INITIAL FIRE SAFETY INSPECTION REPORT

Sterling Denims Ltd. Unit-2

RSC ID: 24673

Date: 5 June 2023

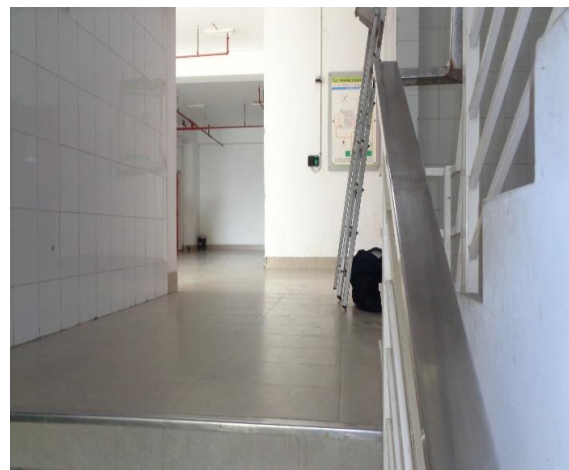
F-2	Fire Rated Construction	Penetrations through floor/ceiling assemblies are found unsealed. Location: Ground floor (Generator Room) of Main Production Building.	Seal all penetrations and openings in floor/ceiling (full thickness of the floor/ceiling: minimum 3 hr.) assemblies by third-party certified fire rated materials to maintain the fire resistance rating. or, Provide a minimum 2-hr fire rated shaft to separate the utility risers from each floor if required.	Within 3 Months
-----	-------------------------	--	--	-----------------
